Technical Bulletin

Bulletin No: TCH-020-018 Effective Date: 10-1-2009

Subject: Changes to Bendix[®] 55250 Caliper Core Classifications

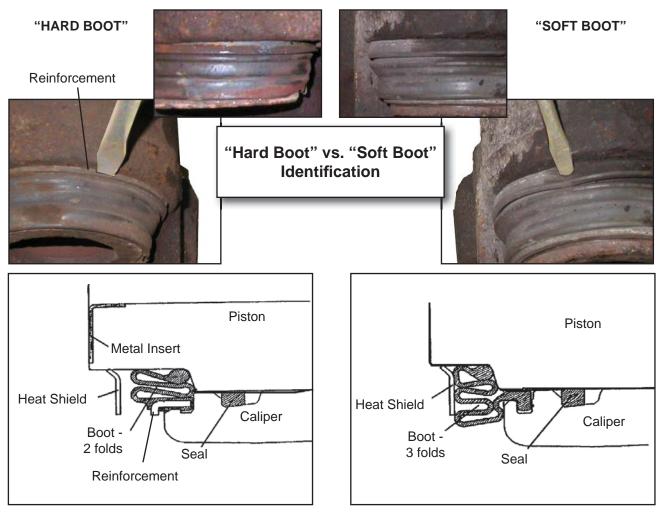
The old "soft boot" style calipers are of a design superseded in 1989 by the improved "hard boot" style. Although the caliper <u>assemblies</u> can be used interchangeably, the <u>component</u> designs are not the same. Caliper machining differences do not allow interchangeability of maintenance kits, components, and therefore cores.

The "soft boot" and "hard boot" calipers can be identified by appearance or by depressing the edge of the boot with a screwdriver as shown in the illustrations below. The "hard boot" style has a hard metal surface in the boot near the caliper bore. The "soft boot" style can be identified by the 3-fold boot design and by the lack of the metal reinforcement near the caliper bore. Casting numbers or other markings can not be used as an identification method.

Effective January 1, 2010 Bendix Spicer Foundation Brake LLC will no longer accept the Pre-1989 "soft boot" style caliper cores, piece number 55250, into core group number 22. These calipers will be accepted under core group **69** only.
